Environmental Assessments & Approvals

AEC 08-019

Re: **Proposed Draft Plan of Subdivision and Zoning By-law Amendment
Laurelpark Inc.
0 Mount Pleasant Road, Part East Half Lot 19, Concession 8 (ALB)
File Numbers: 21T-17006C; RZ 17-09**

The purpose of this letter is to provide you with a response to review comments issued by the Region of Peel (Region), Town of Caledon (Town), Toronto and Region Conservation Authority (TRCA) and Golder related to Azimuth Environmental Consulting Inc.'s (Azimuth):

Photo 1: August 2009 photo (Google Earth) – no houses on Diamondwood Drive.

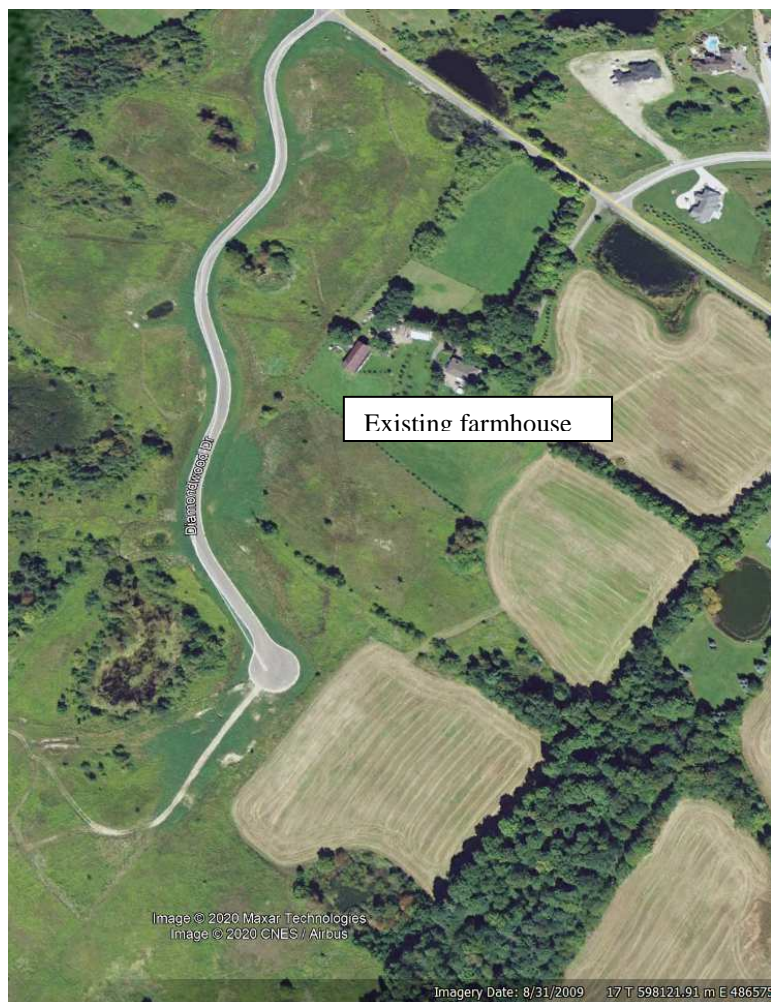
Azimuth Response: The original assessment utilized a background nitrate of 0.2mg/L and had concluded that the higher nitrate concentrations (near 14 mg/L) measured in shallow monitoring wells was due to impacts associated with fertilizer / agricultural practices. Golder identified that the assessment should evaluate the sources and demonstrate that the observed concentrations are not related to other sources that could affect aquifer conditions, notably septic beds from nearby houses.

The water quality samples from the on-site monitoring wells were collected in April 2013 at wells MW3 and MW5. Two of the adjacent houses were under construction in 2013 and the remaining two adjacent houses were built in 2015. This timing sequence was not presented previously. The two monitoring wells are constructed on the periphery of two small on-site wetlands that are polder features and are shallow monitors (3m and 7.6m below ground respectively). The polders collect local runoff from the adjacent farm fields so that the well chemistry reflects this source.

Graph 1: Wetland 1 / MW-3 Hydrograph (2012 – 2013)

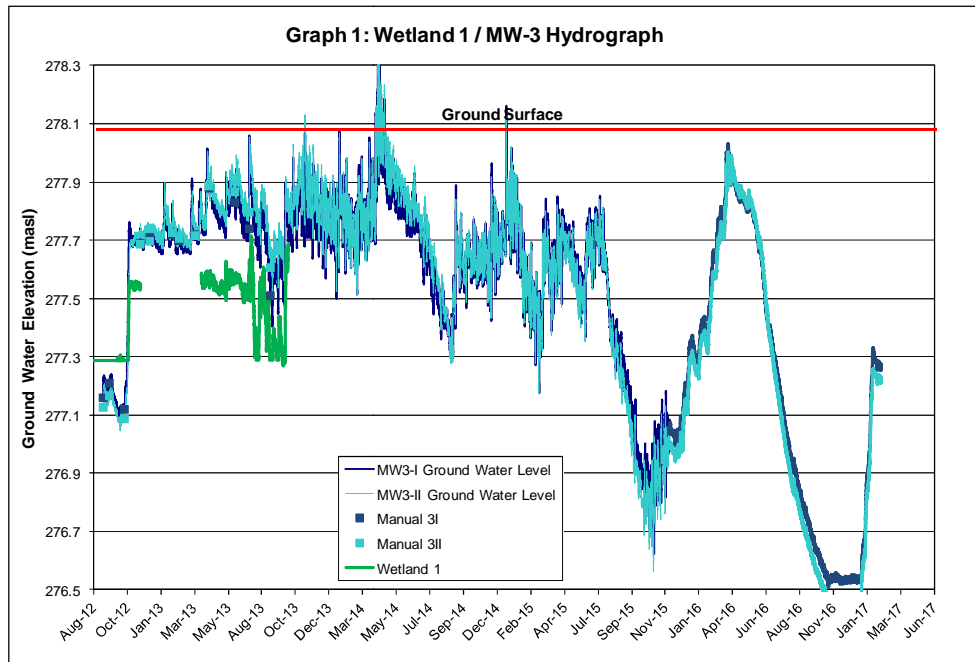
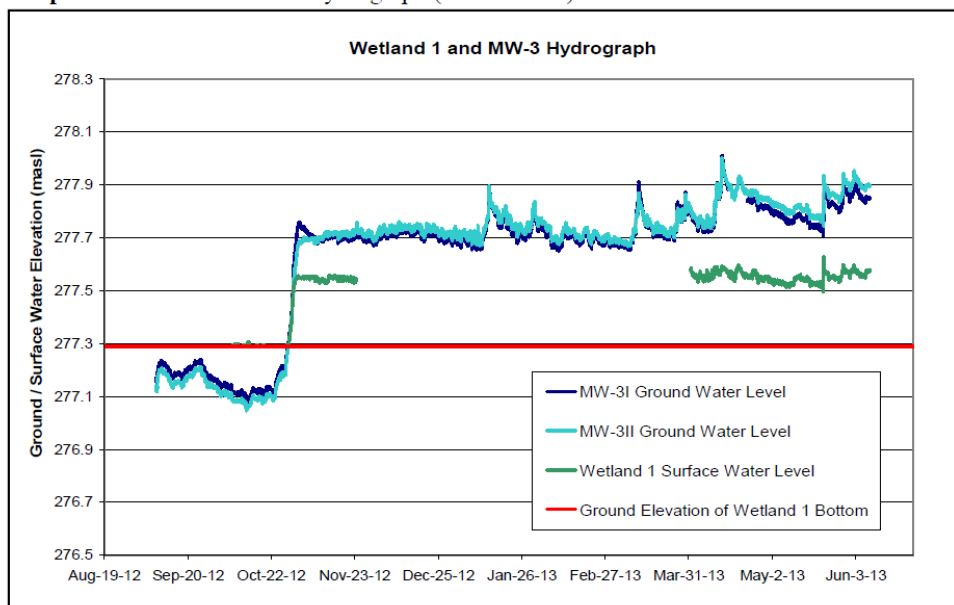
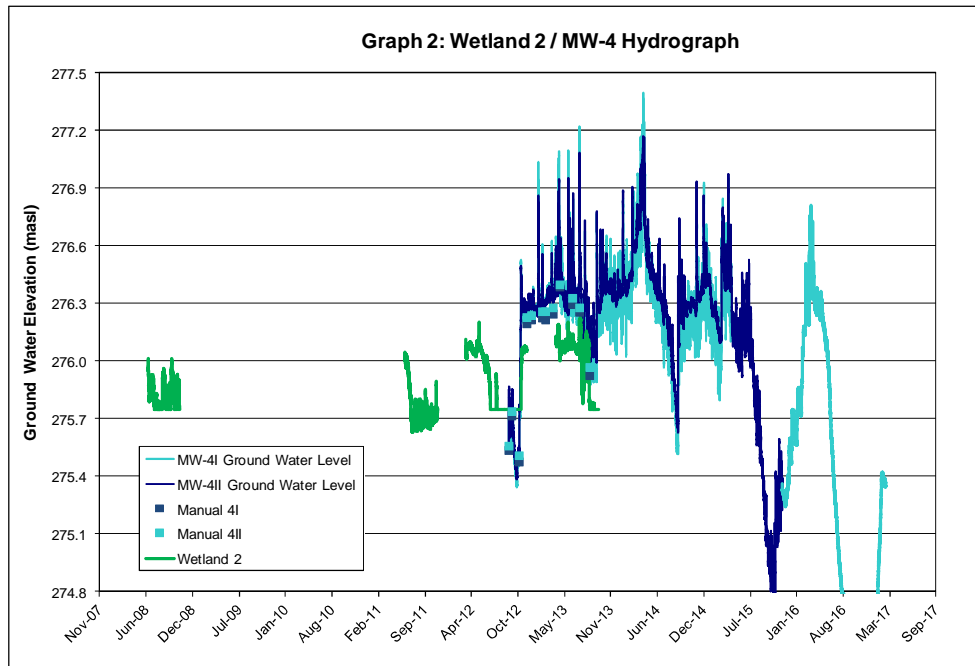
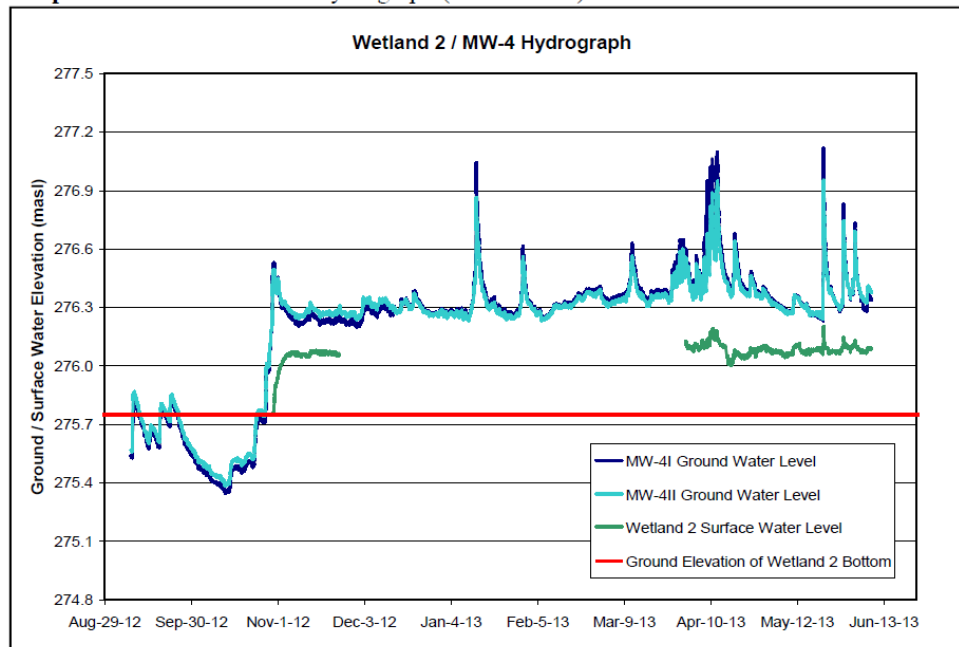
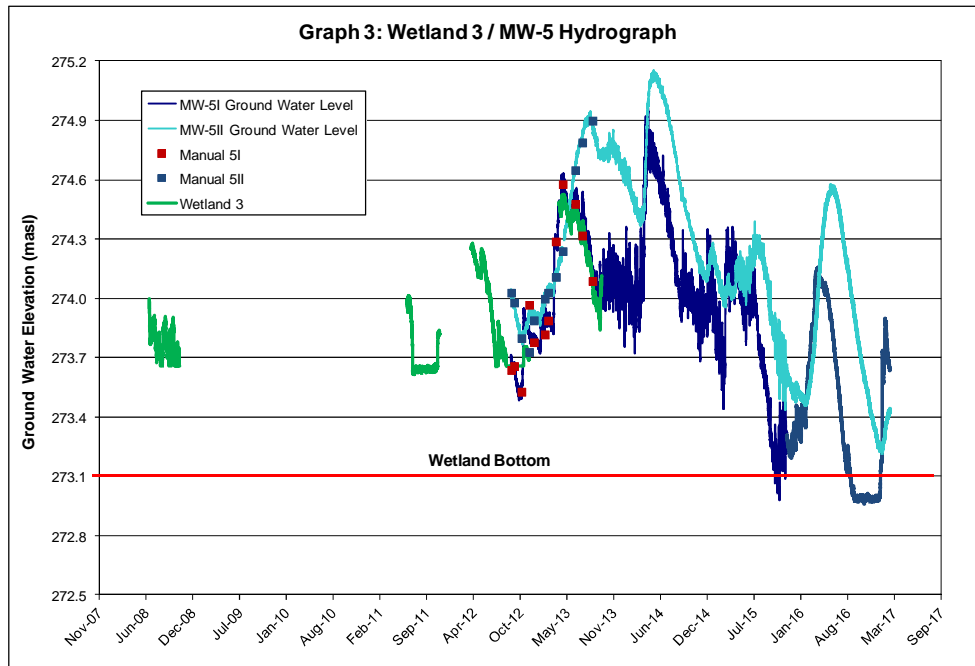
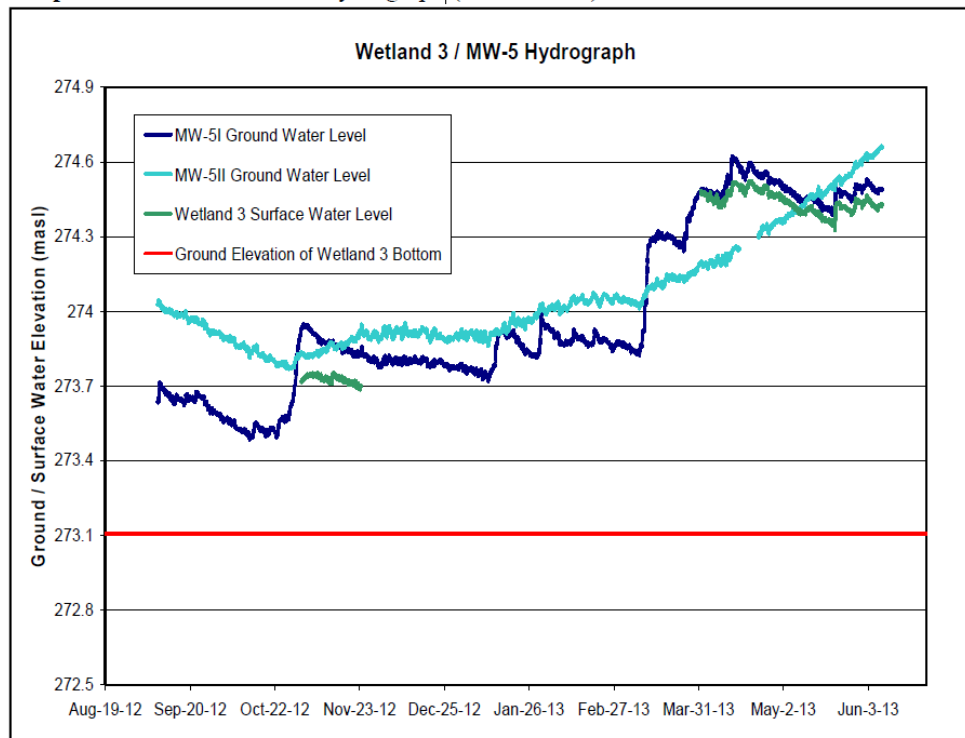
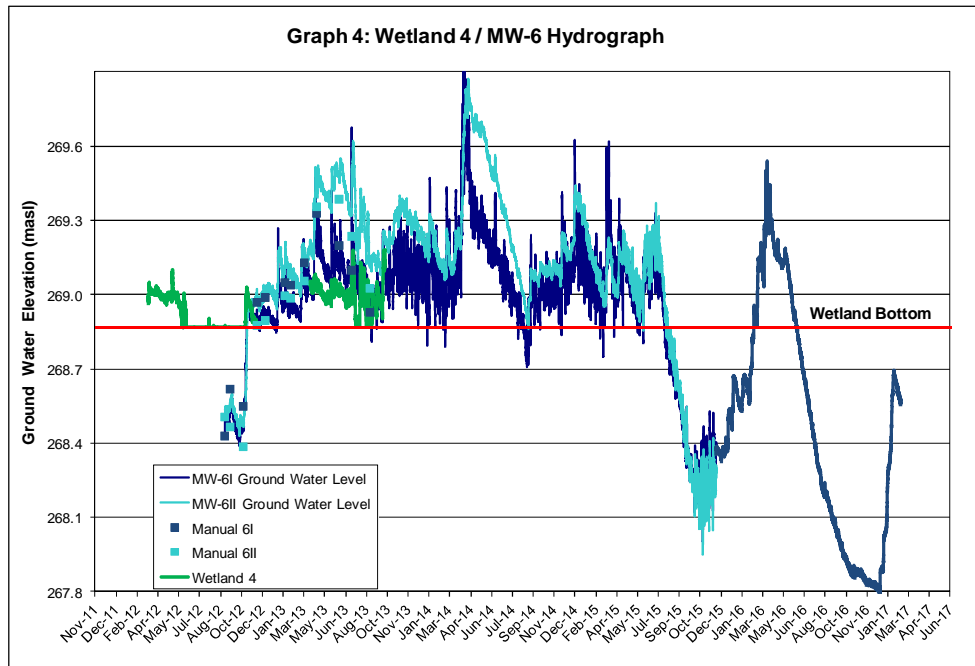
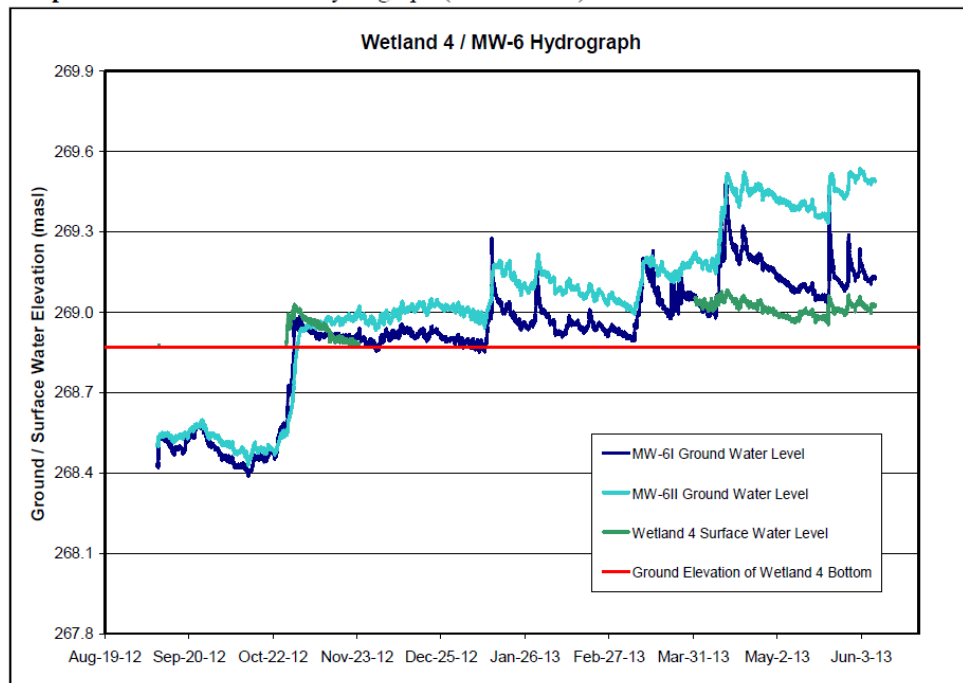
TRCA Comment 22. Thank you for providing additional charts for the data period between 2008 – 2012. However, it was our understanding that Graphs 1 to 5 in the Hydrogeologic Report would be updated with data prior to 2012. Please update all graphs with available data and provide them in an updated Hydrogeologic Report. If monitoring continued beyond 2013, this data should also be added to the charts.

Azimuth Response: The information requested has been appended to our response (Appendix A), but the report graphs continue to be the best reference because they cover the time period when the data sets overlap.

FIGURE 8.1
LAURELPARK SUBDIVISION - PROPOSED TYPICAL 20.0m ROW ROAD CROSS-SECTION
 SCALE: N.T.S.

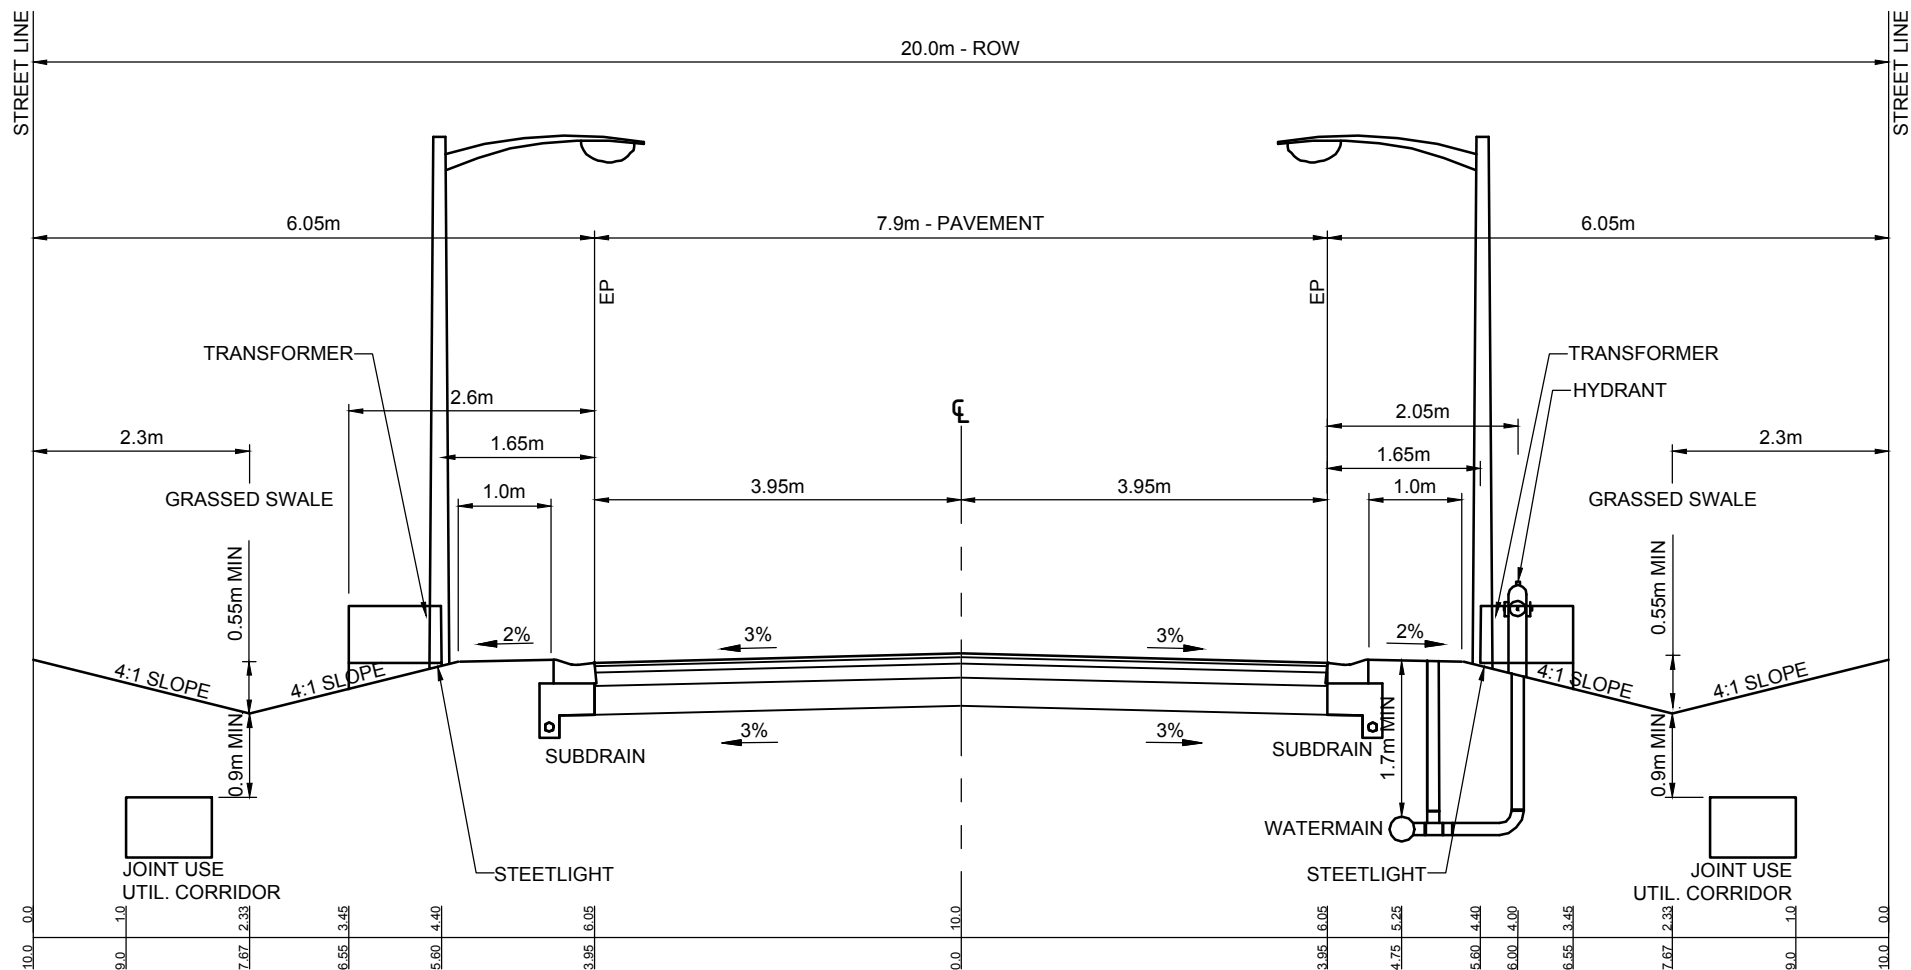
TRCA Comment 3. Thank you for identifying the feature on the plans. Please note that the headwater feature seasonally connecting Block 9 to the offsite wetland south of Block 10 appears to be severed by the proposed road and the catchment area of this feature is proposed to be significantly reduced and altered to road drainage. Moreover, the feature is proposed to direct road drainage through a private property. As such, TRCA staff have the following concerns:

- *Amphibian movement may be impeded by the proposed road;*
- *The water balance of the receiving wetland may be affected;*
- *The conveyance of stormwater from the road onto private property does not provide for long term maintenance/protection of the feature;*
- *The current design of the drainage feature does not emulate that of an enhanced conveyance swale; and*
- *The feature has a rip-rap pad at its terminus without an appropriate transition into the natural system.*

Furthermore, the proposed curb has a height of 50mm with a softer, rounded shape than that of a typical curb (*i.e.* 150mm with a vertical face). Attached is the Ontario Provincial Standard Drawing 600.060 for a semi-mountable curb (Appendix G). An excerpt from the FSR depicting a typical road cross-section is also appended (Appendix G). Since there are no 'typical' curbs, the road does not present an impediment to potential seasonal migration and/or dispersal of amphibians.
